NUMBER: 23-034-05

Liftgate Secondary Seal - Remove Seal If Loose, Misaligned, Or Wrinkled

2005 (WK) Grand Cherokee

Fig. 1 LIFTGATE SECONDARY SEAL

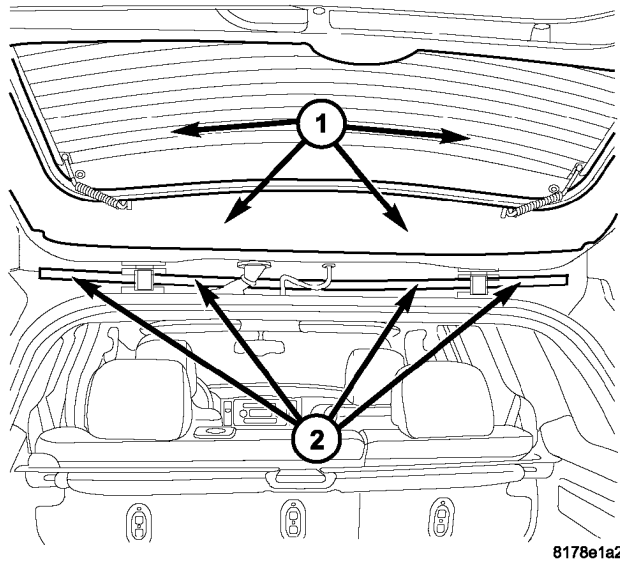
1. Raise liftgate.
2. Remove the three piece liftgate secondary seal from the liftgate (Fig. 1).

- 1 - Liftgate
- 2 - Secondary Seal - Remove (Do Not Replace)

NOTE: Do not install a replacement liftgate secondary seal. The seal is no longer required.
